<b>Licence Number</b>	L7340/1997/9
<b>Licence Holder</b>	Pilbara Iron Company (Services) Pty Ltd
<b>ACN</b>	102 210 248
<b>File Number:</b>	DER2013/000903
<b>Premises</b>	Yandicoogina Iron Ore Mine NEWMAN WA 6753 Being AM70/00254
<b>Date of Amendment</b>	8 January 2018

## Amendment

The Licence Holder has applied for an amendment to construct Waste Fines Cell 5 (WFC5) within the JC pit void. No further areas are required to be disturbed. The pit walls are to form the boundaries of WFC5 to the east, south and western side. Fill material is to form the containment boundary on the northern side. The lowest pit rim elevation is RL 490 m at the northern end and RL 503 m at the southern end (RTIO-HSE-0304263).

**Figure 1:** Stability analysis result - southern end of WFC5, prior to waste fines deposition

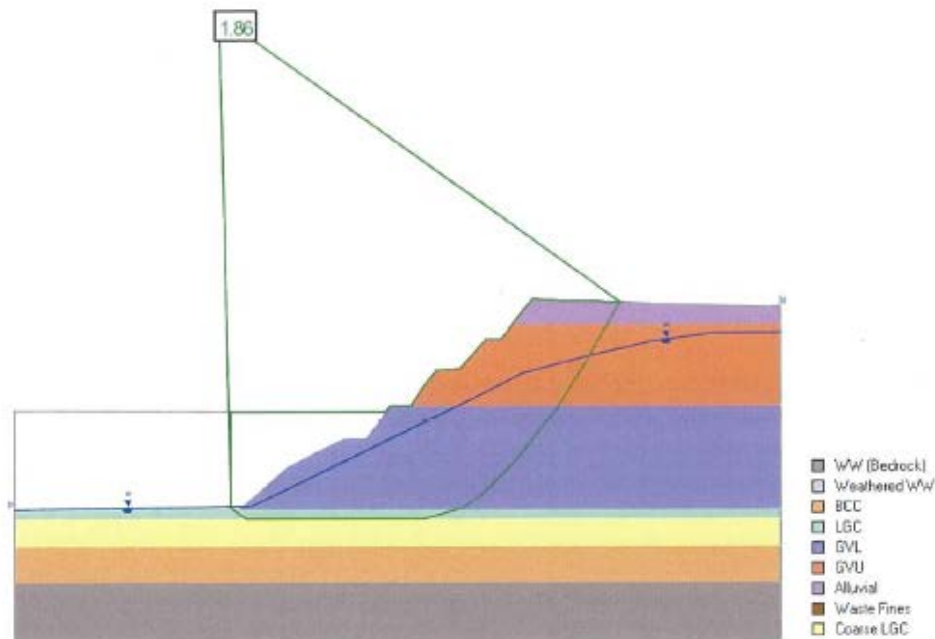
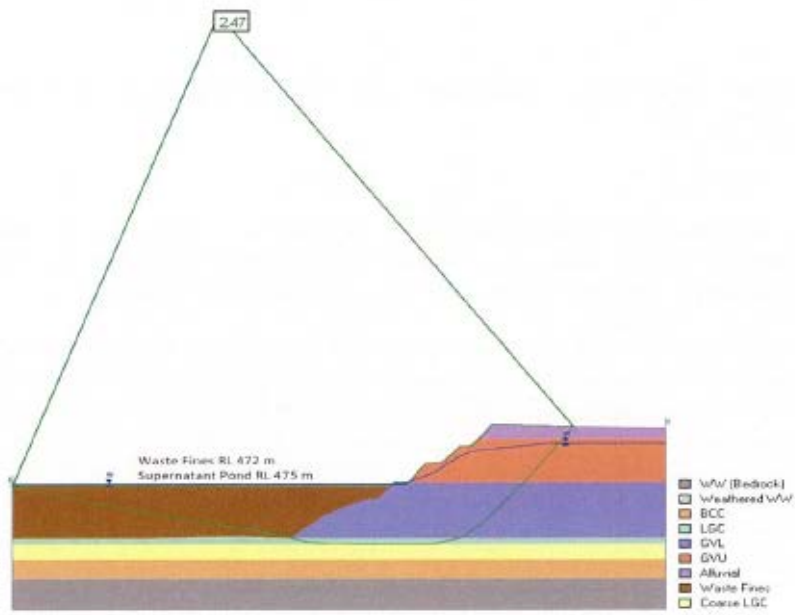
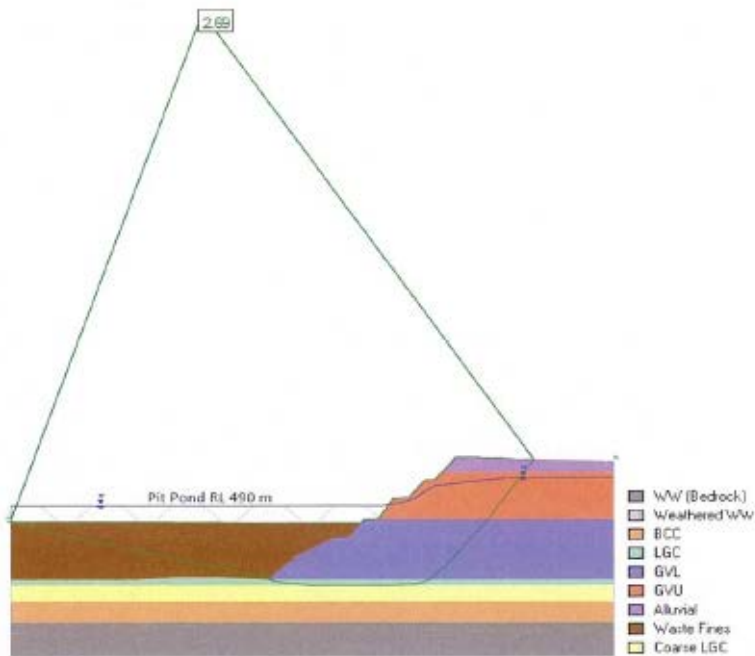
Provide a description of the materials type(s) in the southern wall of the JC pit and the material strength parameters used in the stability analysis; and the details of the stability analysis of the southern wall of the pit.

**Table 1:** Summary of material strength parameters for geotechnical stability analysis

Material	Unit Weight (kN.m <sup>3</sup> )	Strength Parameters			Data Source
		Friction Angle $\phi'$ (°)	Cohesion $c'$ (kPa)	Undrained Vertical Stress Ratio	
Surface Alluvial	17	25	20	-	Rio Tinto
Weathered Weeli Wolli Formation	27	35	335	-	Rio Tinto
Weeli Wolli Formation	27	35	335	-	Rio Tinto
Upper Vitreous Goethite (GVU)	27	40	427	-	Rio Tinto
Lower Vitreous Goethite (GVL)	27	32	308	-	Rio Tinto
Limonite Goethite Clay (LGC)	18	Shear Function			Golder Estimate based on presence of clay lenses (Golder, 2016b)
Coarse LGC	25	40	100	-	Golder Estimate
Basal Clayey Conglomerate (BCC)	22	35	335	-	Rio Tinto
Saturated Waste Fines	20	-	-	0.05	Golder Estimate

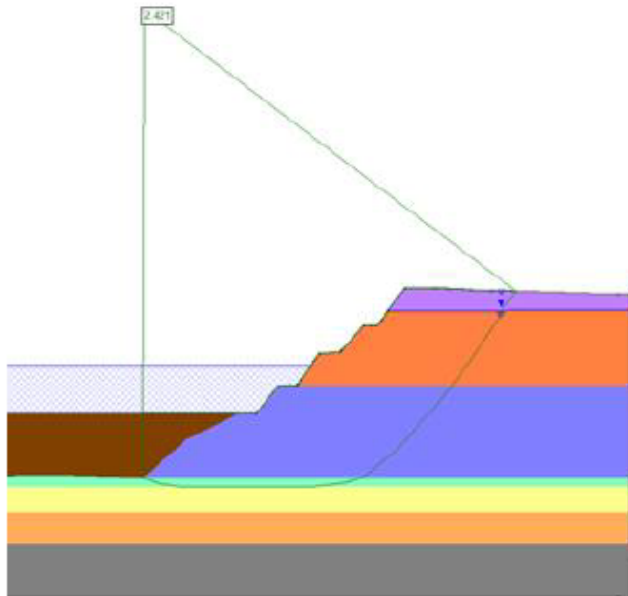
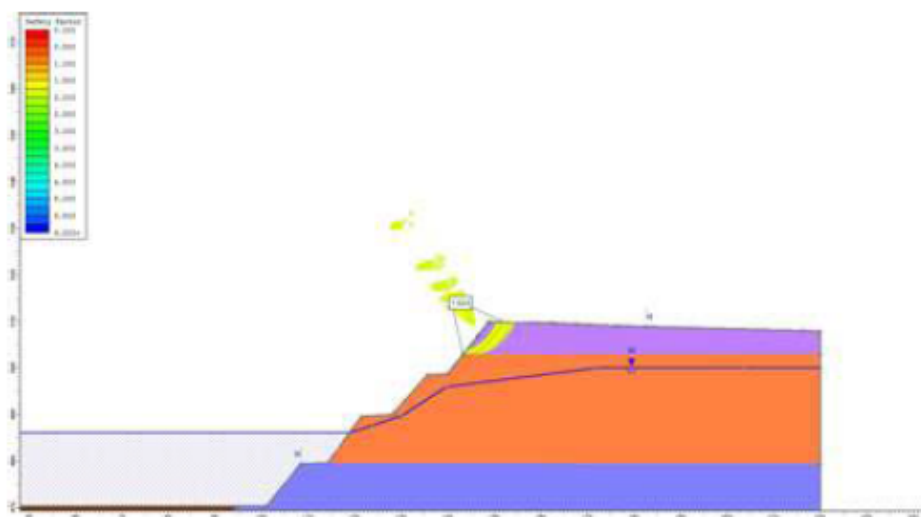
An assessment of the potential for saturation of the pit wall materials due to extreme rainfall leading up to the flood, and due to the flood itself; and

An assessment of the long term stability of the southern wall of the pit, taking into account the potential saturation of the pit wall materials as mentioned above and any surcharge load from a PMF.

With regards to long term stability and saturation of the southern pit slope, we have considered the overall stability of the slope at maximum pit lake level (RL 490 m). The lowest pit rim elevation is at RL 490 m at the northern end and RL 503 m at the southern end. The resultant FoS against failure is 2.7. The relatively high phreatic surface is visible in the figure below and failure of the upper portions of the slope is unlikely due to the competent nature of the material.

Full saturation of the pit slope has also been considered to provide certainty around the stability of the southern slope of WFC5. We believe this scenario is highly unlikely as the pit can only fill up to RL 490 m which is the lowest pit rim elevation. The factor of safety against failure is 2.4. The relatively high phreatic surface follows the pit slope outline and is visible in the figure below.
